Oct.21, 2002

To: T10 Technical Committee

Re: SAS Bit Ordering Diagrams Change Proposal

**Figure 35 – SAS bit transmission logic**

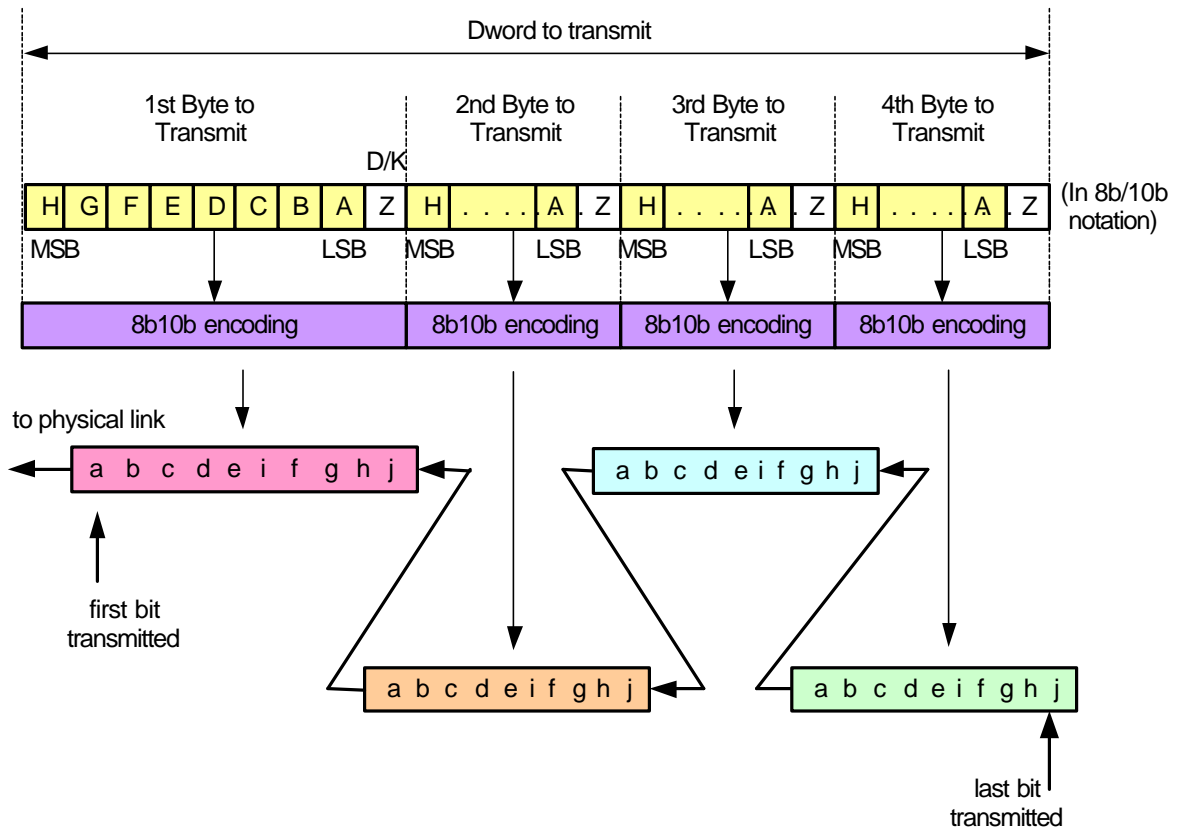
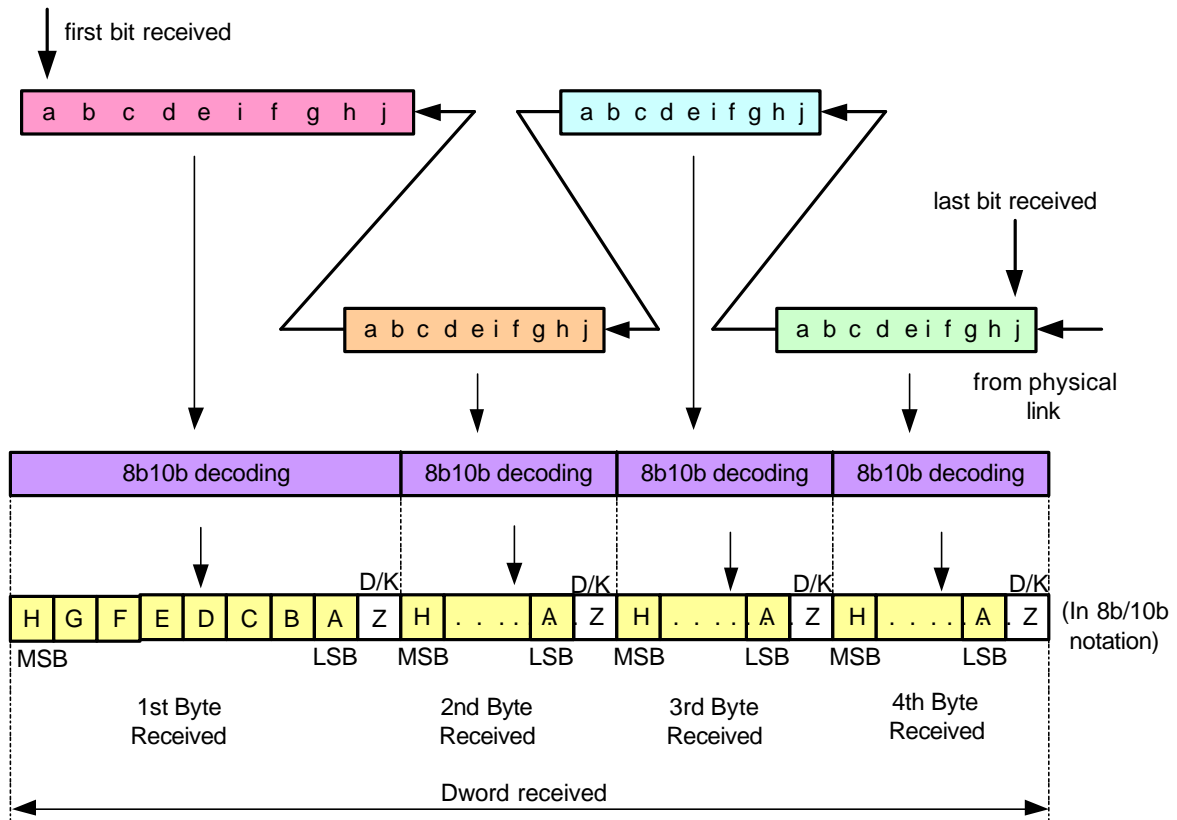
- 1) Figures 35 and 36 incorrectly show bit transposition being done within each byte of a dword prior to the 8b/10 encoding/decoding logic. Propose that these diagrams get replaced with the following diagrams:

**Figure 55 – SSP/SMP CRC generator/checker byte and bit order**

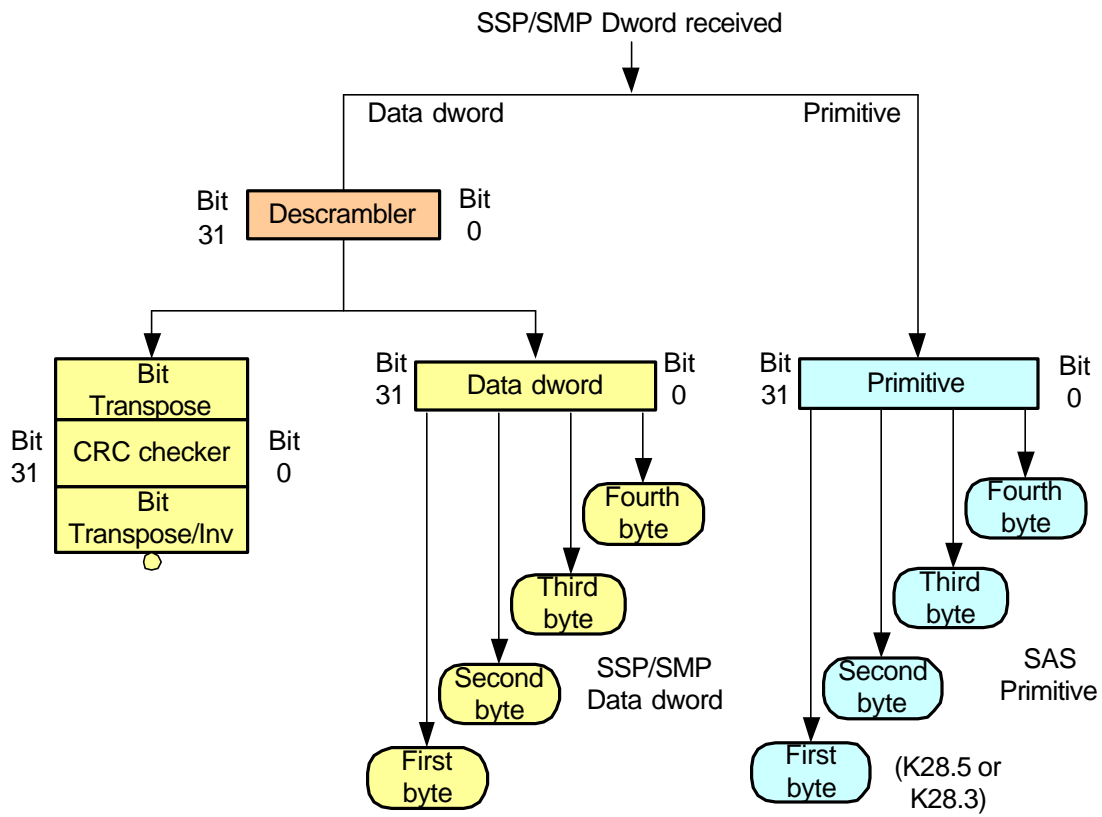
2) Figure 55 is missing bit inversion at the output of the CRC generator. Propose to replace with the following figure which shows the outputs being inverted:

**Figure 56 – SSP/SMP Transmit path byte and bit ordering**

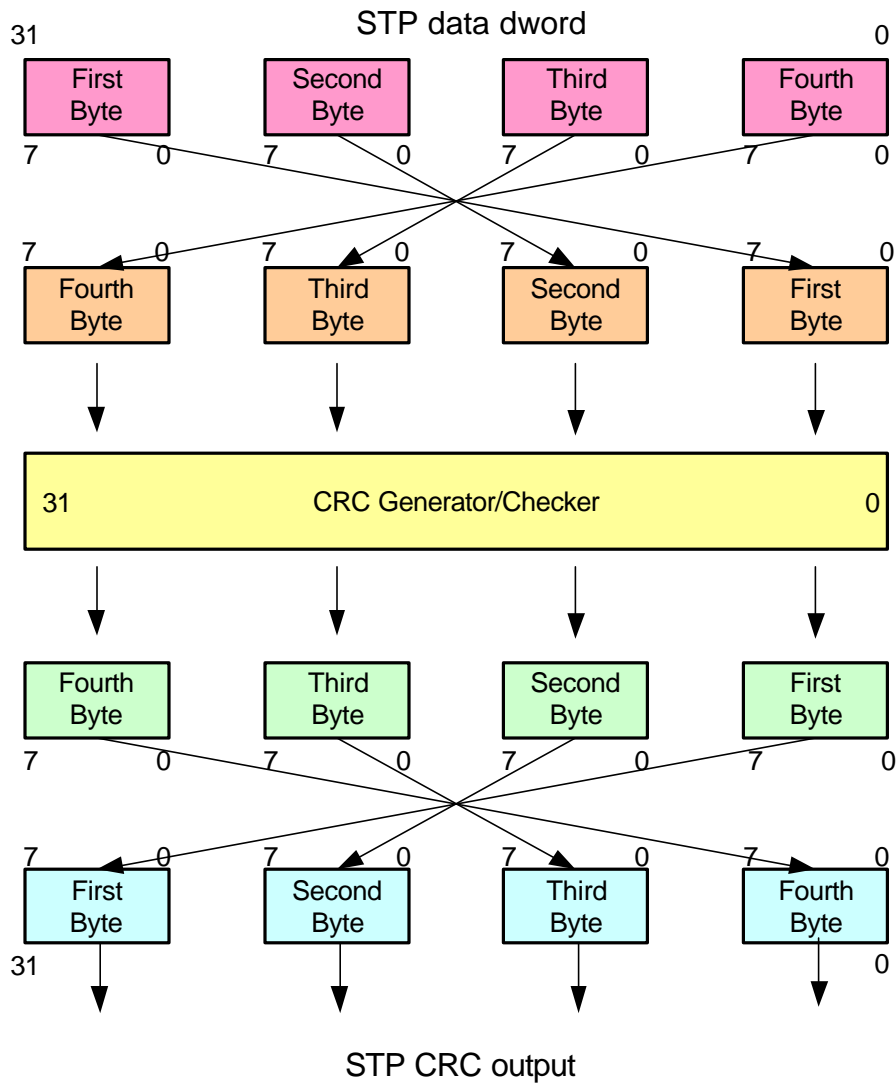
3) Figures 56 and 57 do not show the bit transposition and inversion logic associated with the SSP/SMP CRC generator/checker. Propose to replace with the following figures:

**Figure XX – STP Transmit path byte and bit ordering**

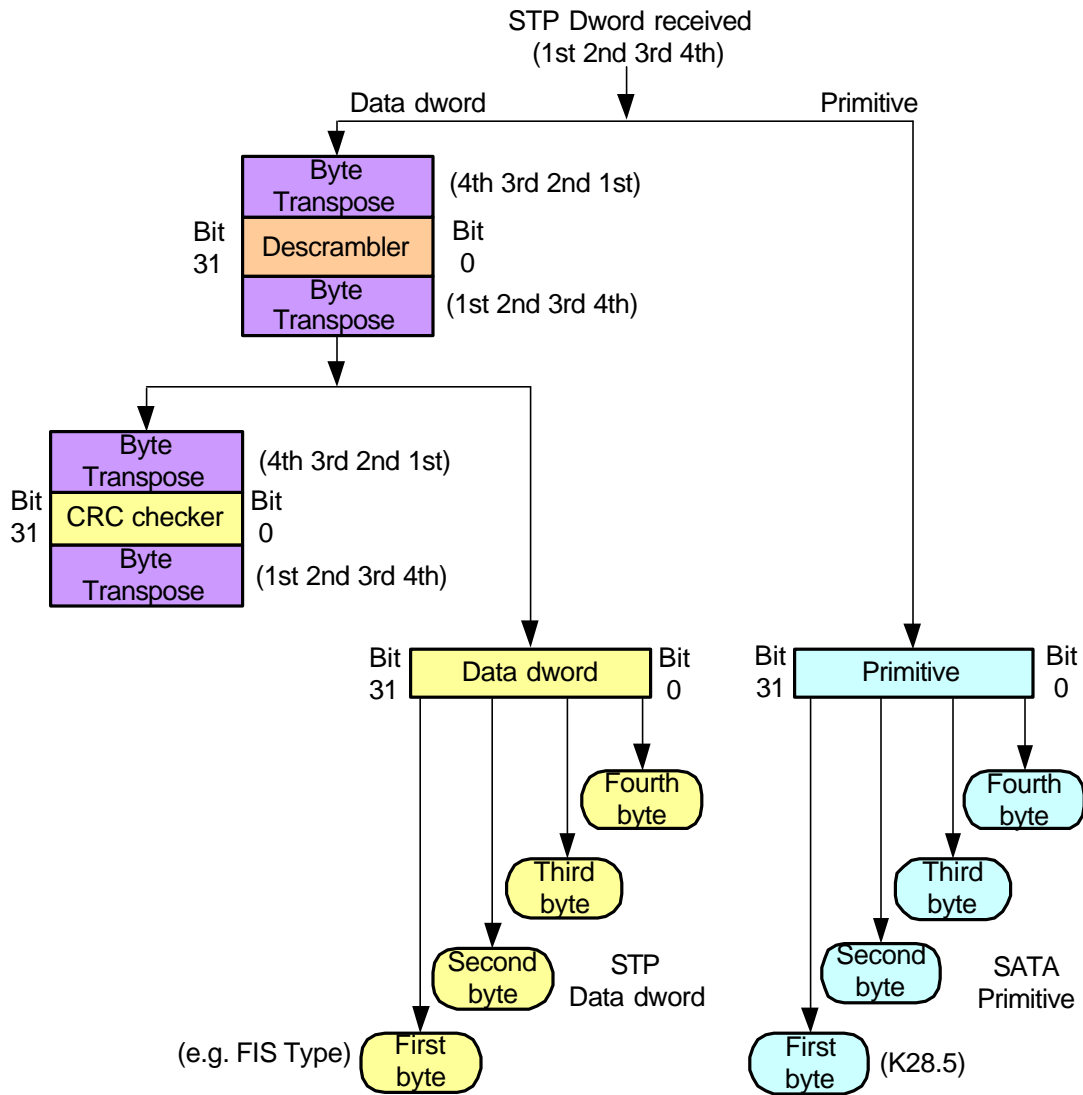
4) Propose that three diagrams be added to clarify the byte ordering for STP data paths and the difference between SSP, SMP and STP CRC requirements.
